STATE OF VERMONT
AGENCY OF TRANSPORTATION

PROJECT LOCATION
HARTFORD-RANDOLPH
ER-0147(21)

RECORD PLANS

PROJECT DESCRIPTION
ROAD EMBANKMENT STABILIZATION, CULVERT REPLACEMENT, AND OTHER RELATED ITEMS

**D4-14-24
RANDOLPH**

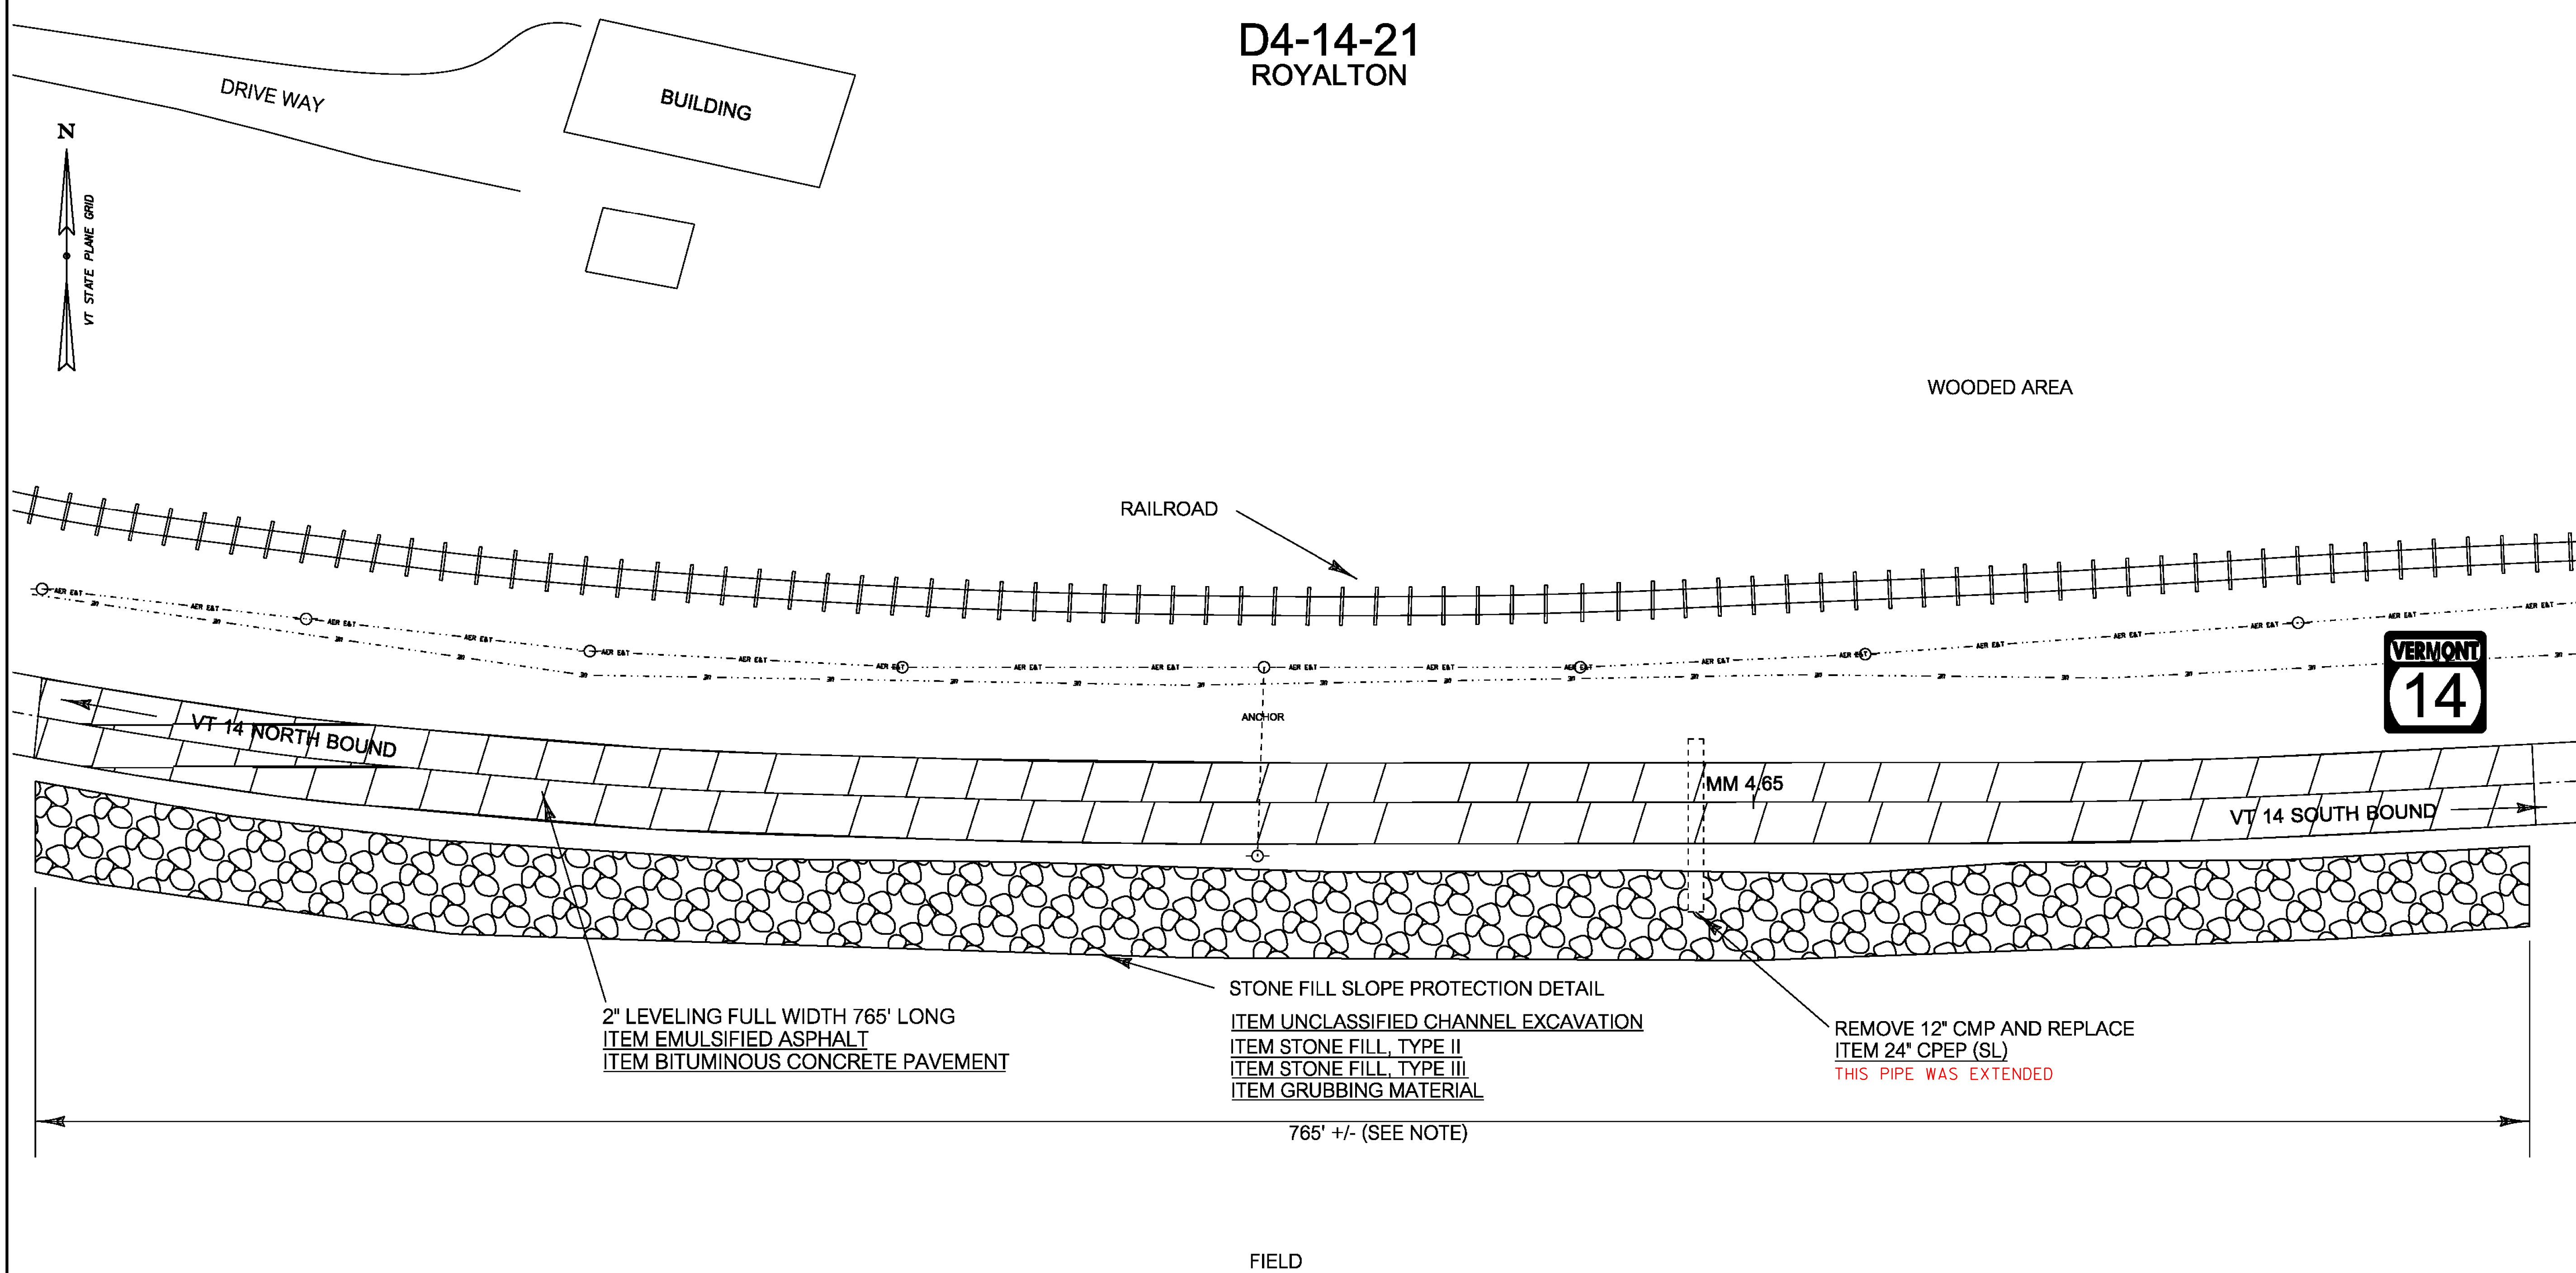
STONE FILL ADDED

D4-14-6 HARTFORD

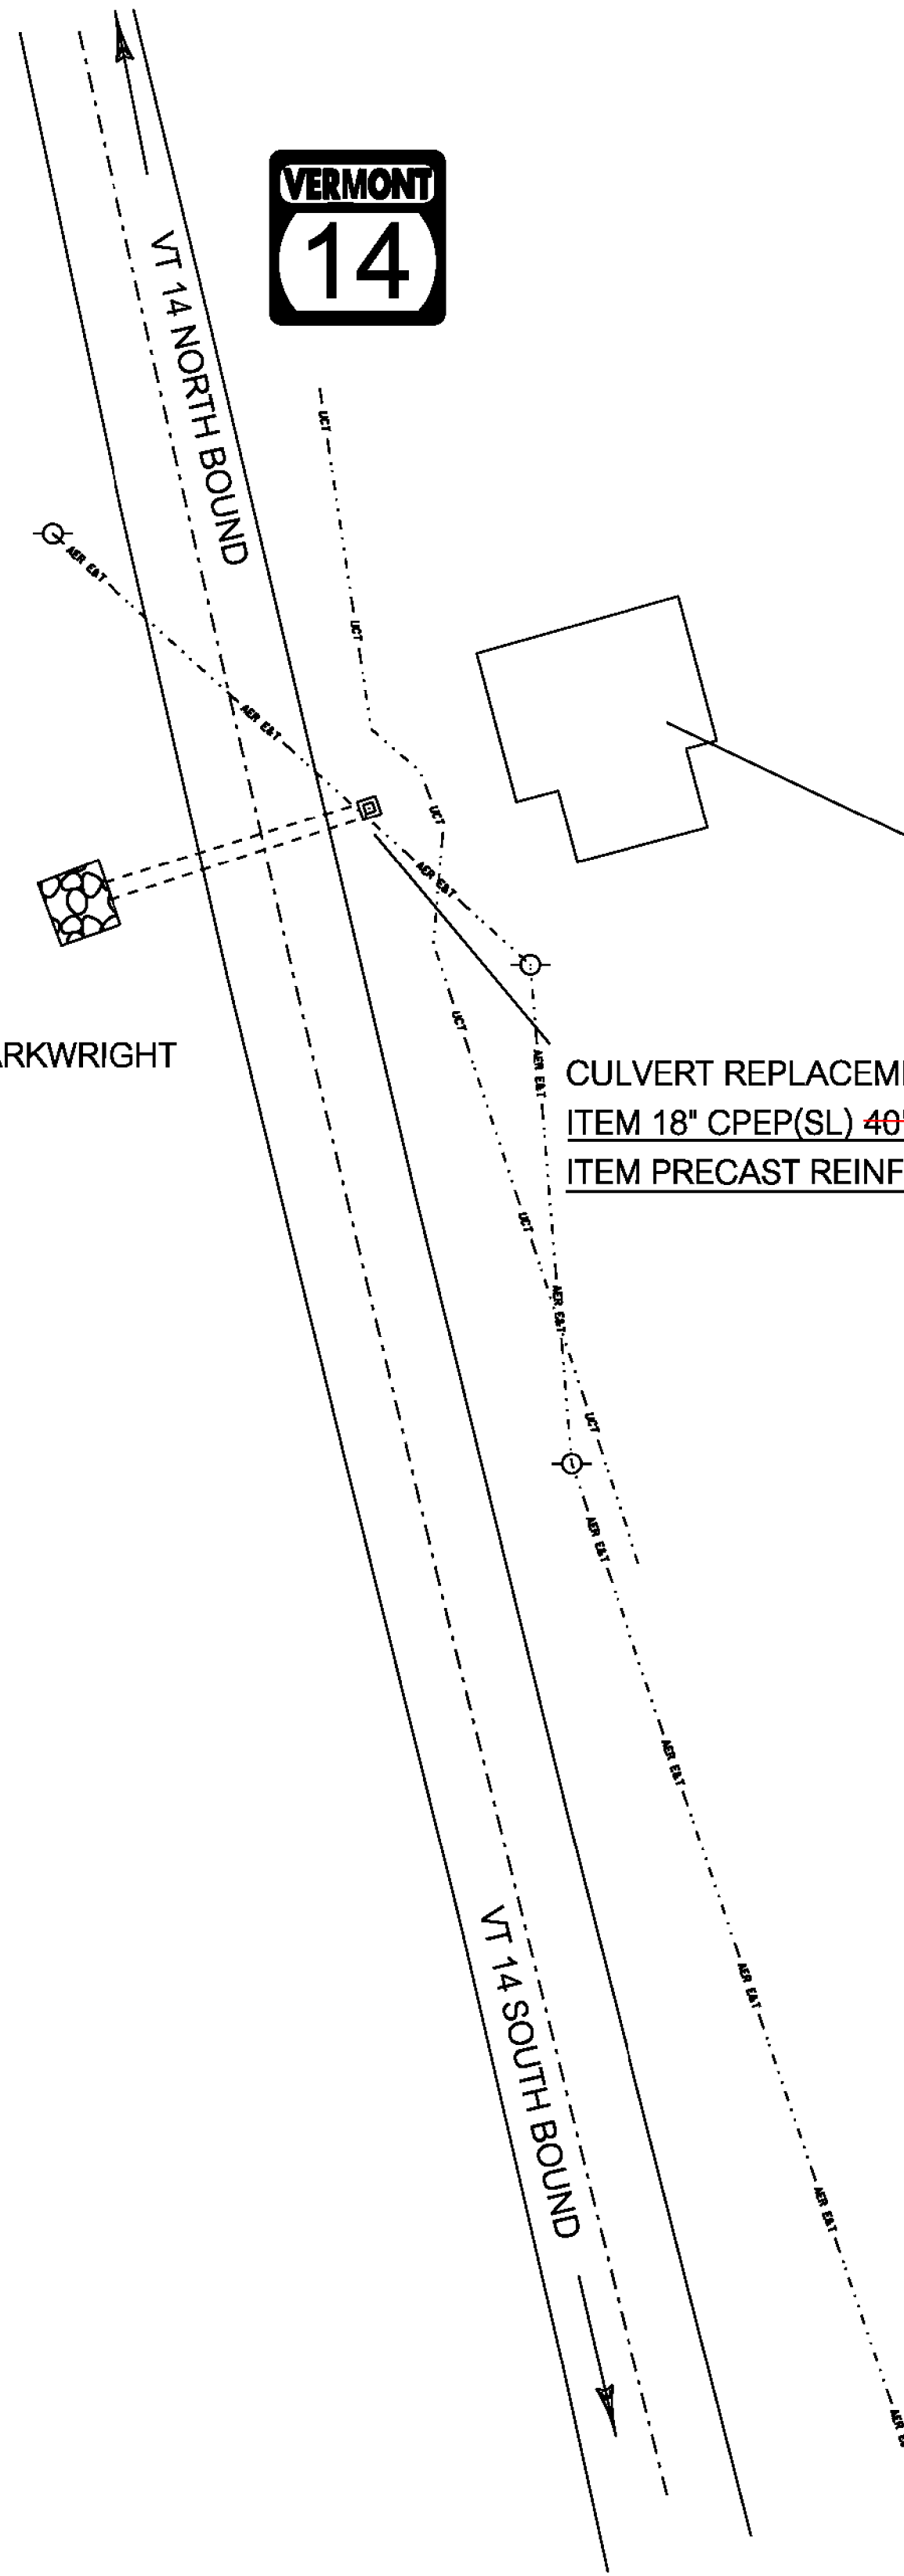
CULVERT REPLACEMENT @ MM 7.06 EXIST 18" REPLACE WITH
ITEM 18" CPEP(SL) ~~40' LONG~~ 64' LONG DAYLIGHTED TO EDGE OF SLOPE
ITEM PRECAST REINFORCED CONCRETE CATCH BASIN WITH CAST IRON GRATE
